Checking Report

Wi Column

Wembley Innovation Limited

Clegg Associates Ltd was requested by Wembley Innovation (WI) to carry out a Category 3 check of a technical comparison between Wi columns and Ancon WP2 windposts.

Refer to CADS wall panel calculation sheet W140/MaxL/01:

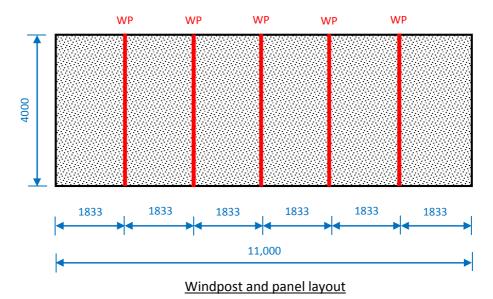
The typical panel detailed on Sustainability Check – Calc No W140/MaxL/01 has passed the independent design checks, which are presented in Appendix A of this report. Due to methods of analysis employed or analytical approach taken some calculations may have returned slightly different (although comparable) results from WI calculations.

British BS5628 Manuf Control - Category 1 Construction Control - Special	Flexural Stress Allowable - 0.697 kNm/m Actual - 0.709 kNm/m	Utilisation 1.02
Eurocode 6	Wall Design Moment	Utilisation
Manuf Control - Category 1	Allowable - 0.757 kNm/m	0.930
Class 1	Actual - 0.705 kNm/m

As such, Clegg Associates have no adverse comments on the typical panel (as listed above) presented for checking by WI.
